DEPARTMENT OF TRANSPORTATION**Federal Aviation Administration****14 CFR Part 39**

[Docket No. FAA–2011–0994; Directorate Identifier 2010–NM–143–AD; Amendment 39–16949; AD 2012–03–08]

Airworthiness Directives; Bombardier, Inc. Airplanes

ACTION: Final rule.

Figure 1
LH side shown
RH side opposite

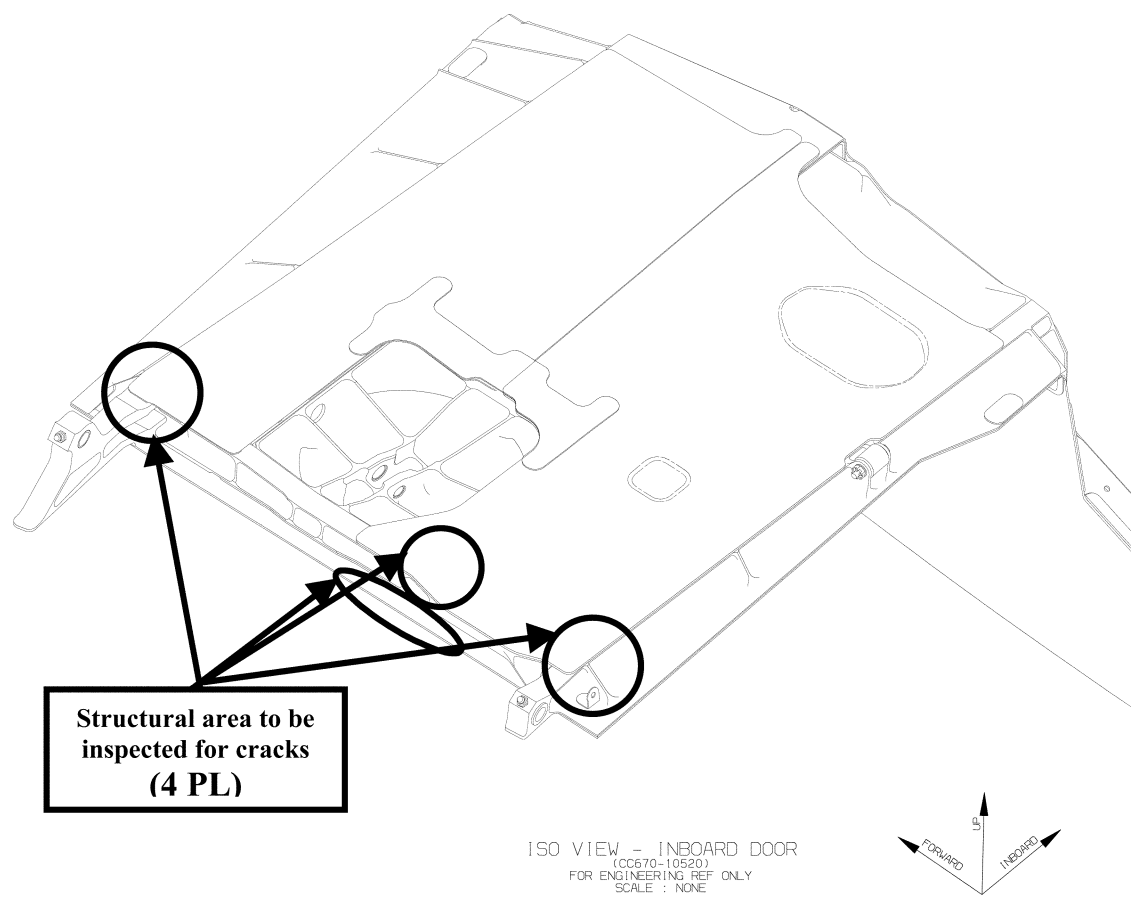
(4) Inspect the forward member, P/N CC670–10570, and aft member, P/N CC670–10571, of the MLG door lower panel for cracking or deformation, or pulled or missing fasteners, in accordance with Figure 3 of this AD. Figures 1 through 3 of this AD follow.

Figure 2
View LKG INBD
LH side Shown
RH side Opp

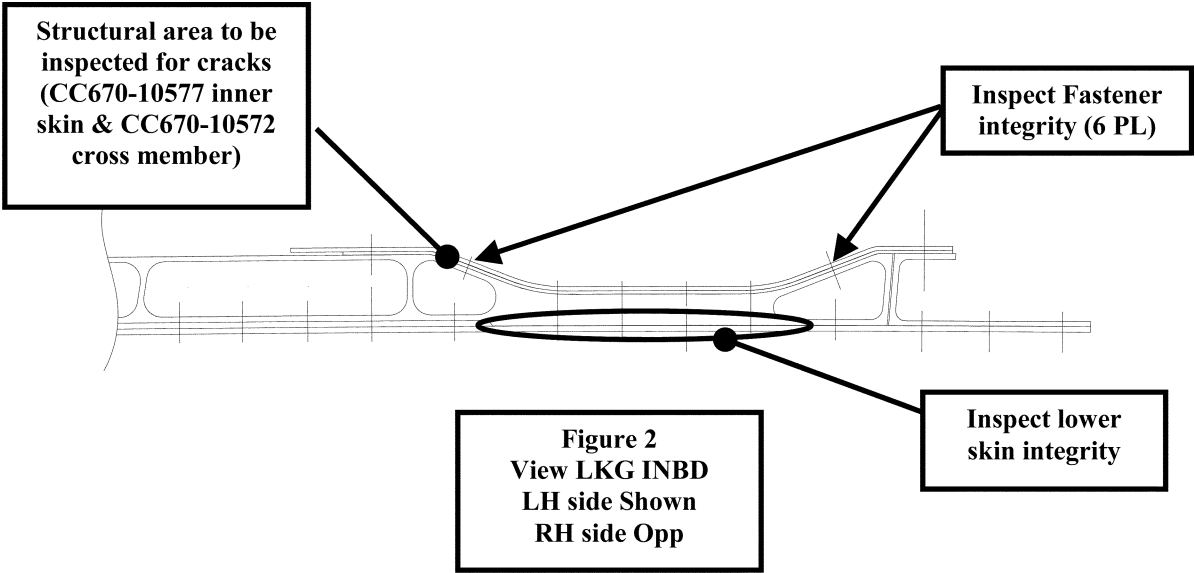
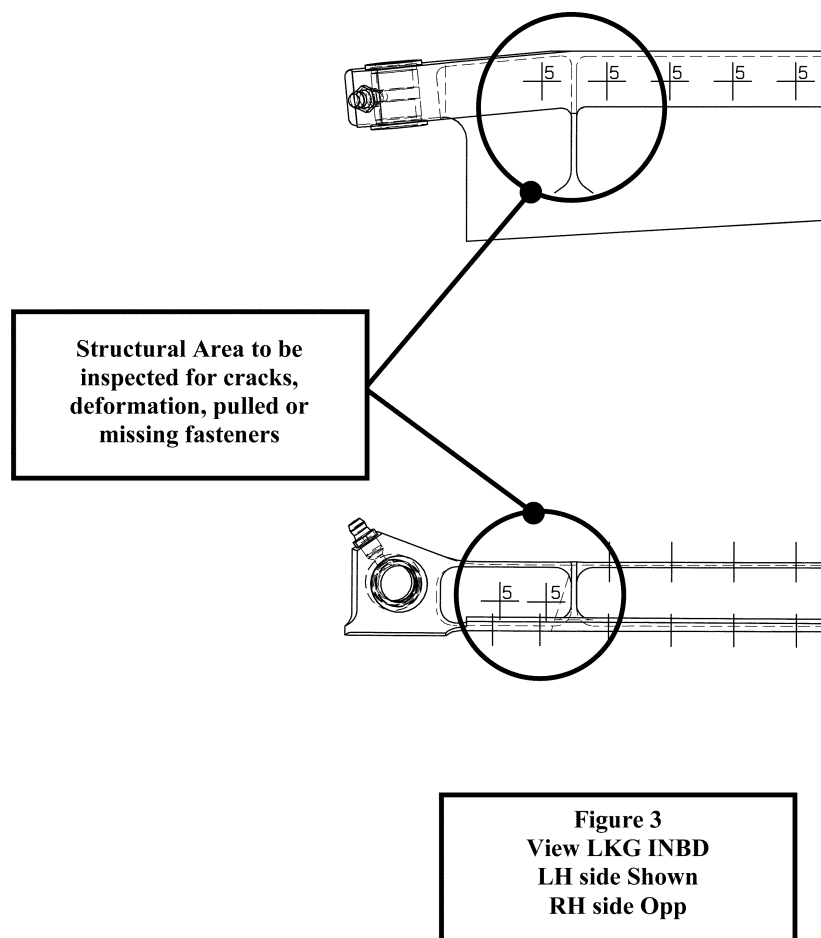
(1) Inspect the cross member, P/N CC670–10572, of the MLG door lower panel for cracking or deformation, in accordance with Figure 2 of this AD.

(2) Inspect the inner skin, P/N CC670–10577, of the MLG door lower panel at the cross member (P/N CC670–10572) for cracking or deformation, or pulled or missing fasteners, in accordance with Figure 2 of this AD.

(3) Inspect the outer skin, P/N CC670–10574, of the MLG door lower panel at the cross member (P/N CC670–10572) for cracking or deformation, or pulled or missing fasteners, in accordance with Figure 2 of this AD.
